SECTION 00 91 13
ADDENDA

- A. Project Name: Sioux Falls VA Health Care System Campus; improve Campus Building Exteriors.
- B. Owner Project Number: 438-22-600.
- C. Architect: Stone Group Architects Inc., 600 E. 7th Street, Sioux Falls, South Dakota, 57103.
- D. Architect Project Number: 221926.
- E. Date of Addendum: August 13, 2026.

**D6** **ROOF PLAN**
1/8" = 1'-0"

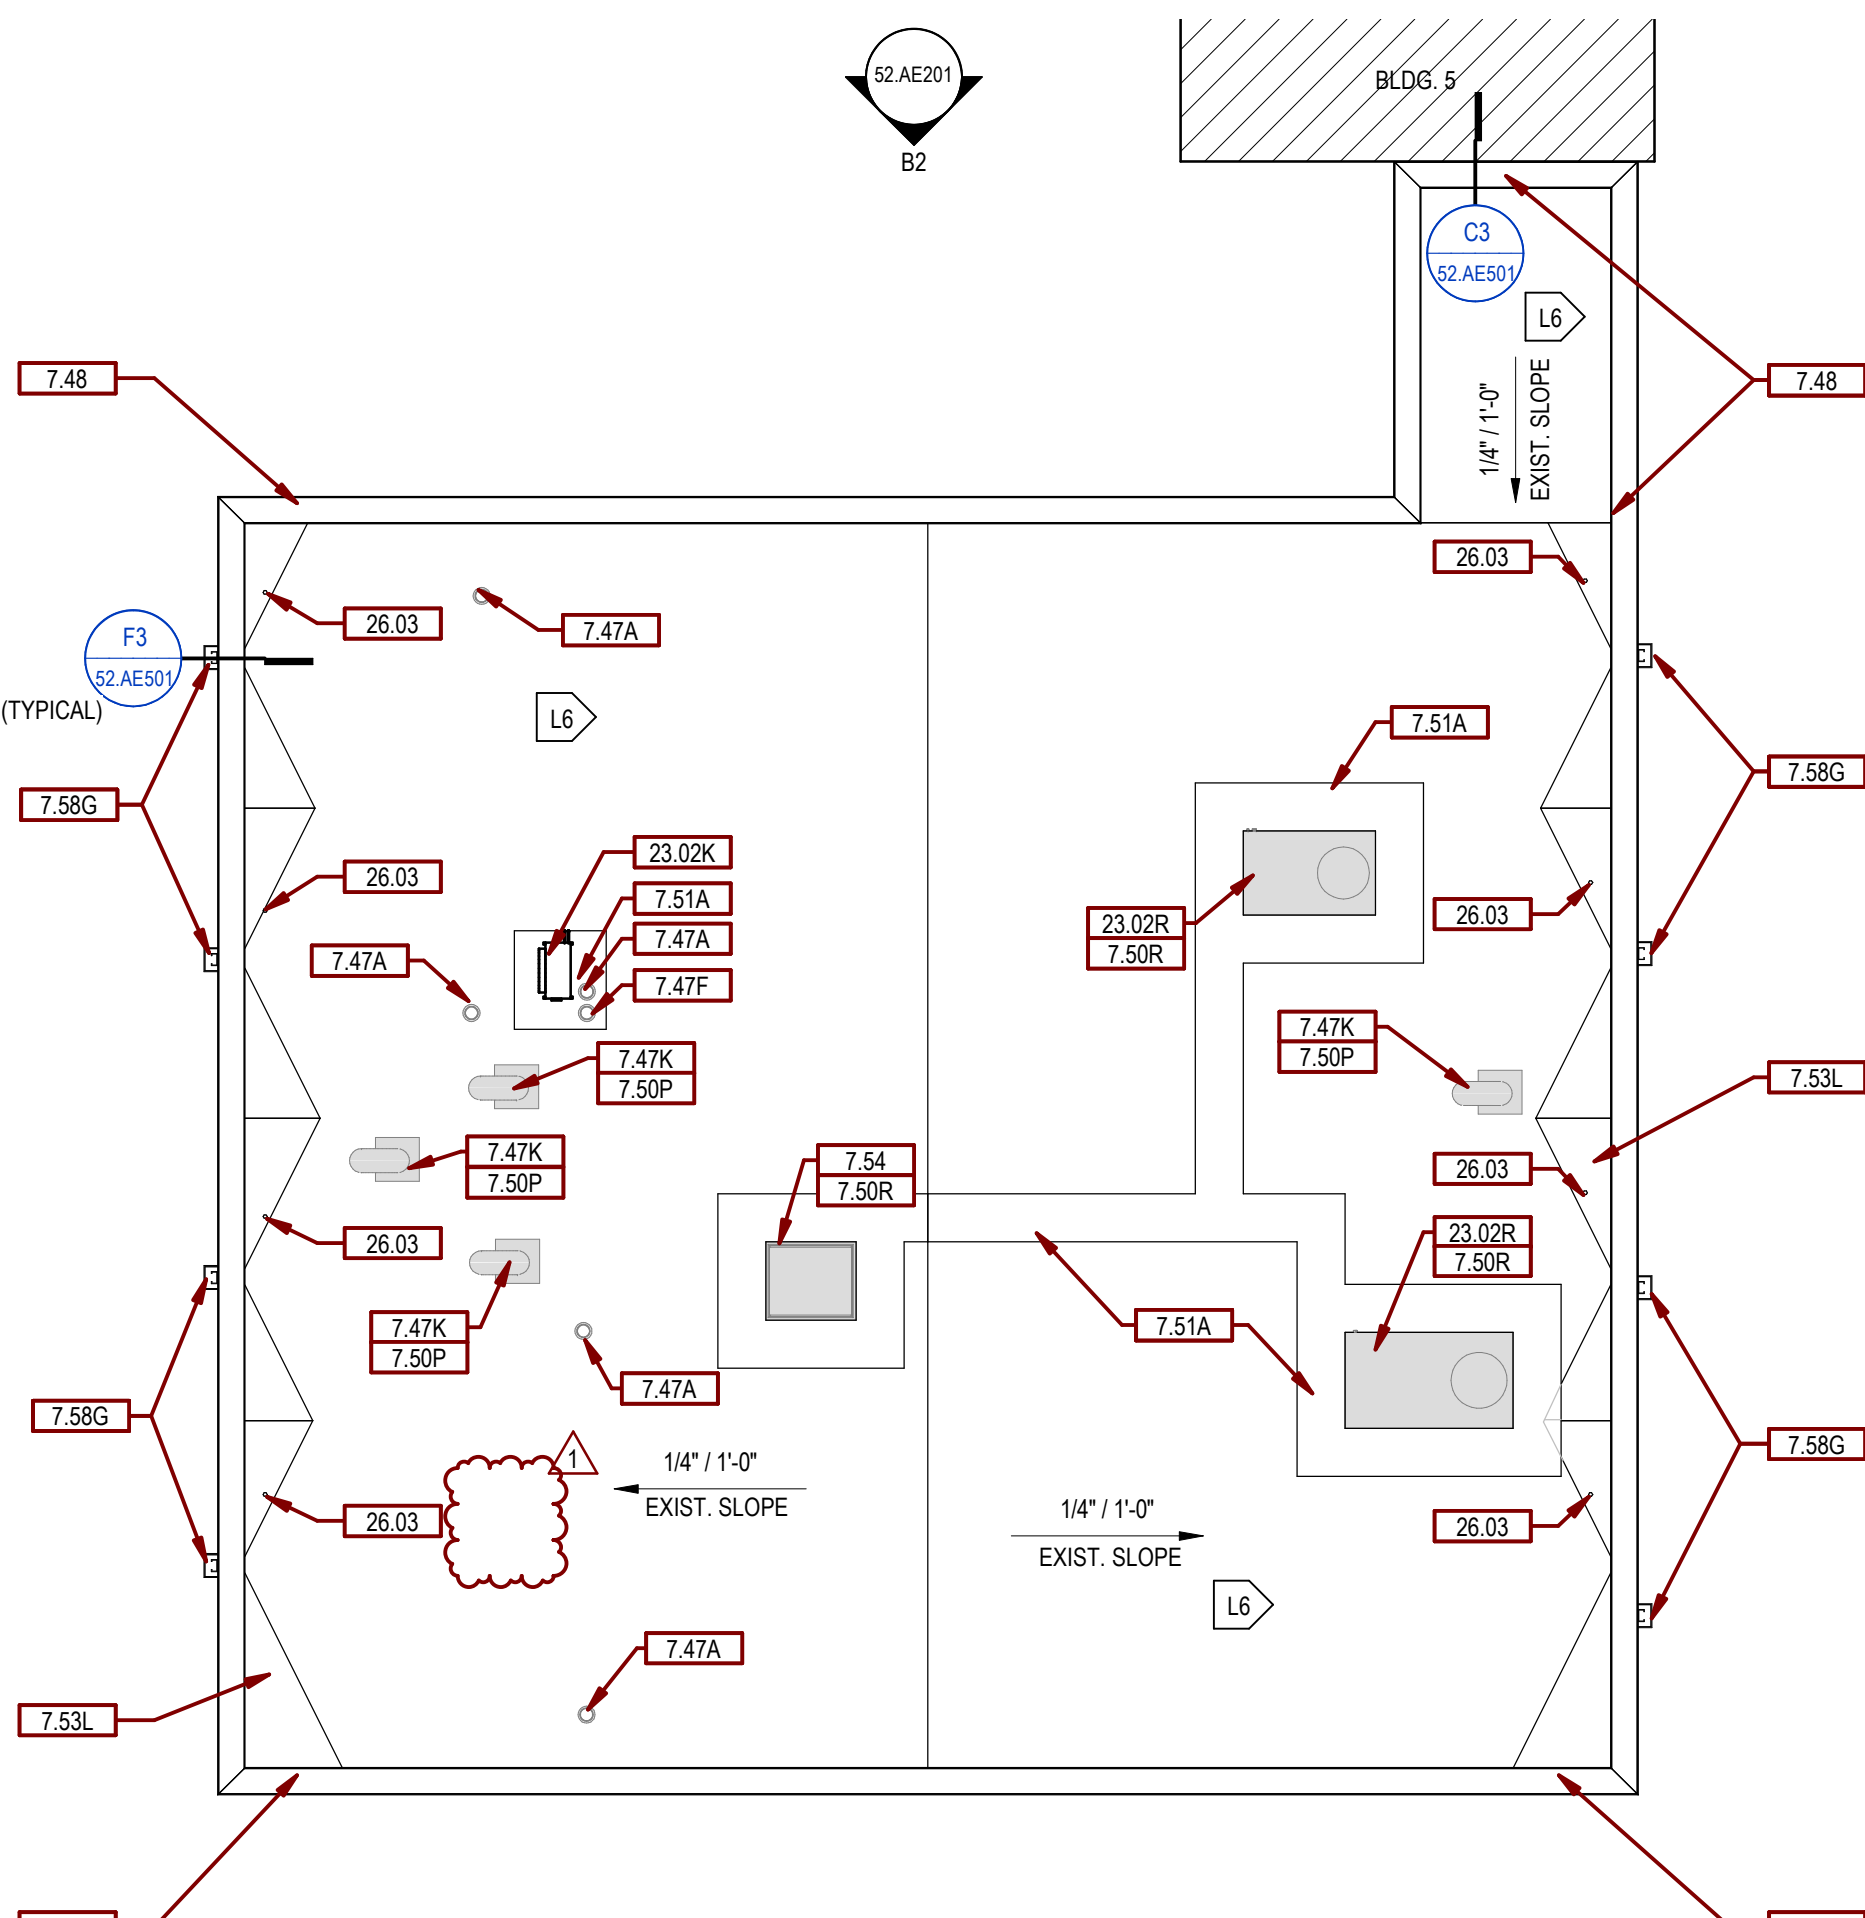
- A. Sheet G-001 ARCHITECTURAL PHASING AND SITE PLAN, (reissued).
 - 1. Added cover board to Roof Type L6.
- B. Sheet 52.AE121 ARCHITECTURAL ROOF PLAN (reissued).
 - 1. Drawing D6: Removed detail F7 call out.
 - 2. Keynotes: Added "cover board" to keynotes 7.50P, 7.50R and 7.53L.
- C. Sheet 52.AE501 ARCHITECTURAL - DETAILS (reissued).
 - 1. Detail C1: Corrected note arrows.
 - 2. Detail C3: Added cover board to roof and parapet wall.
 - 3. Detail F3: Added cover board to roof and parapet wall.
 - 4. Deleted Detail F6.
 - 5. Deleted Detail F7.
